## Service Bulletin

**Bulletin No:** JC-19-05

**Product Type:** 450 Steiner Tractor

**Customer Issue:** Leaking Rear Hydraulic Oil filter seal

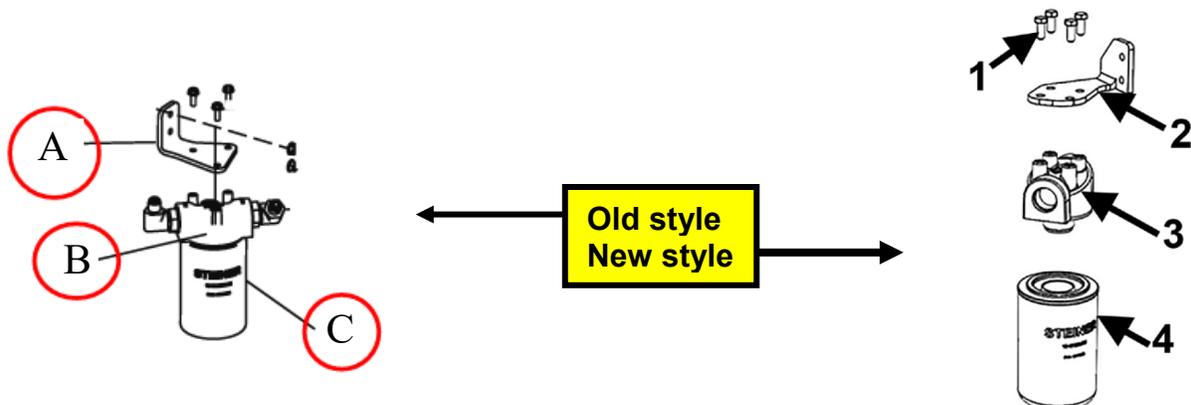
**Cause:** Two possible causes to the filter leaking:

1. The filter may not be tightened to the filter head sufficiently.
2. Under certain operating conditions not all tractors will experience, the filter seal may be insufficient for internal system pressures.

Remove the red circled items A-C shown below on the left and replace with kit components shown on the right. This repair can be completed from under the seat without removing the bottom skid plate if the filter is tightened onto the filter head prior to installation.

1. For tractors brought to dealer for a rear hydraulic leak complaint or other service check to make sure the filter has been tightened at least  $\frac{1}{4}$  turn onto the filter head past the snug position. If not, re-tighten to one full turn past snug. If the filter is tightened past  $\frac{1}{4}$  turn, then replace the components with the updated filter kit (**4177733**).
2. We are asking that all dealer stock (unsold units) get updated with filter kit (**4177733**) and apply a fix-as-fail for units already in service that are leaking in the field.
3. Order this kit (**4177733**) thru your normal parts channel.
